Lewis County
West Main Street Complete Streets Project
Lewis County Project No. 5120.8A.25
BCA Project No. 2025-036

Addendum No. 1
April 16, 2026

**WEST MAIN STREET
COMPLETE STREETS
PROJECT**

CATCH BASIN DETAIL
NOT TO SCALE

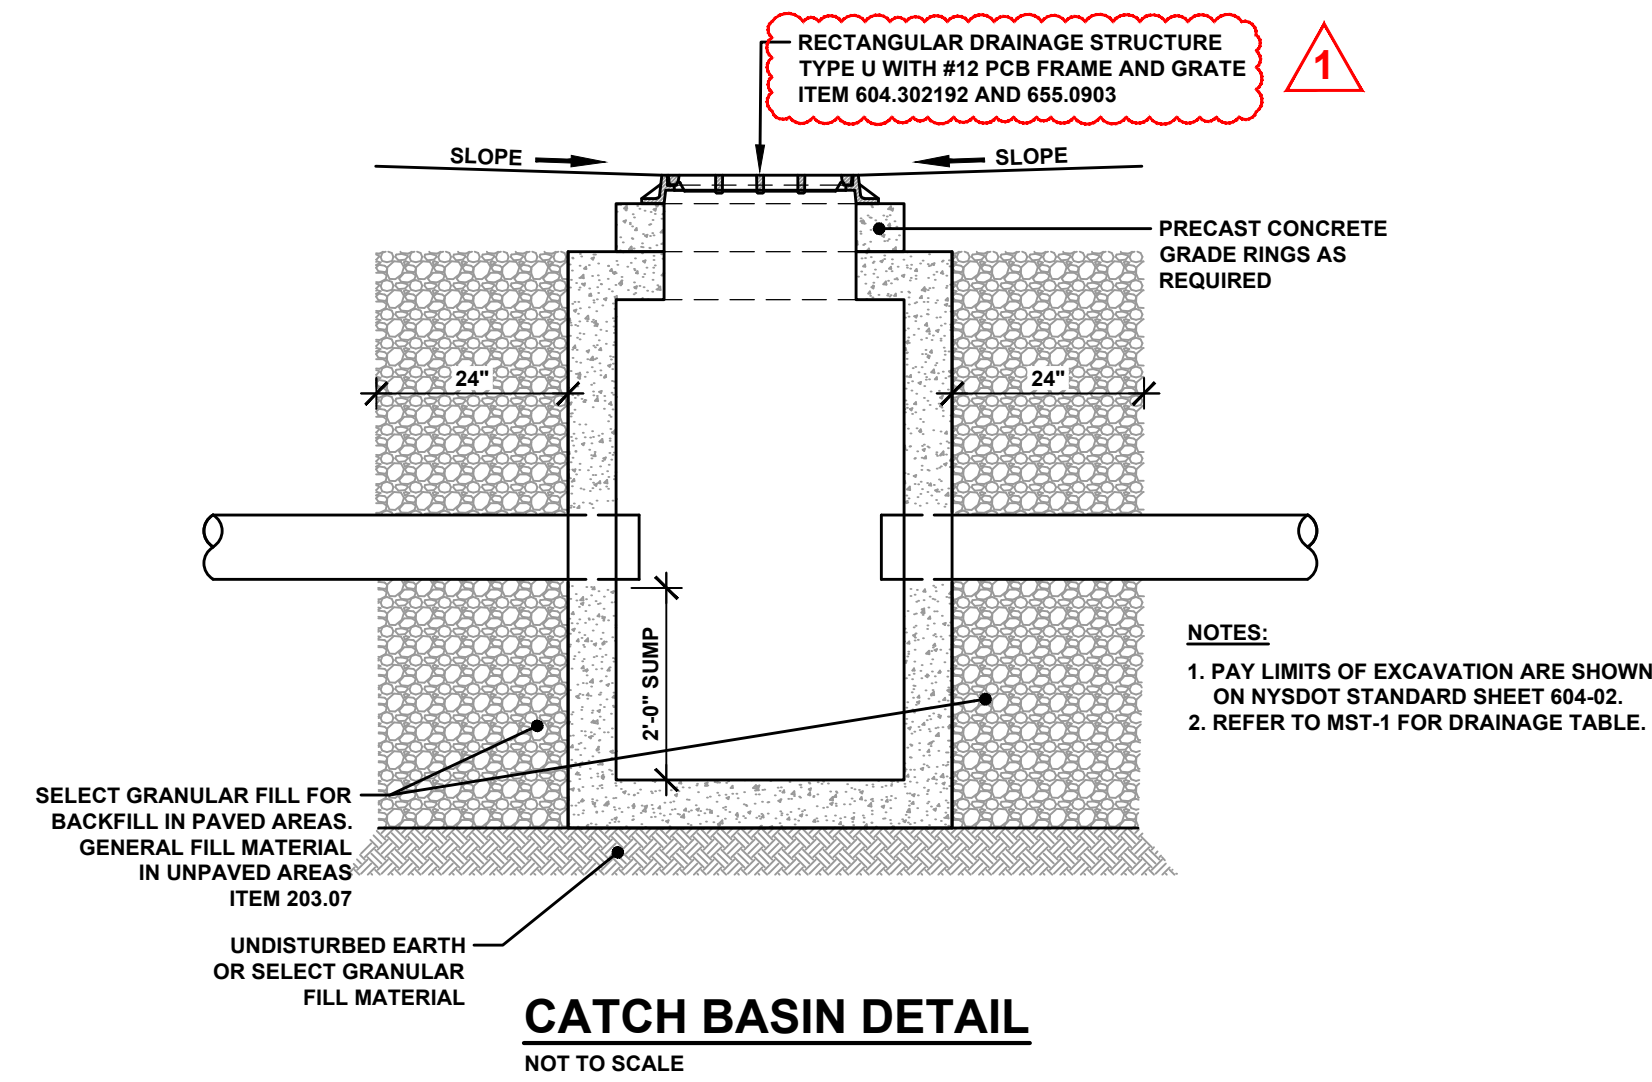
5. **Reference Sheet MD-8:**
 - A. **REPLACE** “Rectangular Drainage Structure Type A with #3 Welded Frame, Item 604.300190 and 655.0901” with “Rectangular Drainage Structure Type U with #12 PCB Frame and Grate, Item 604.302192 and 655.0903”.

Addendum 1 (4/16/26): CATCH BASIN DETAIL
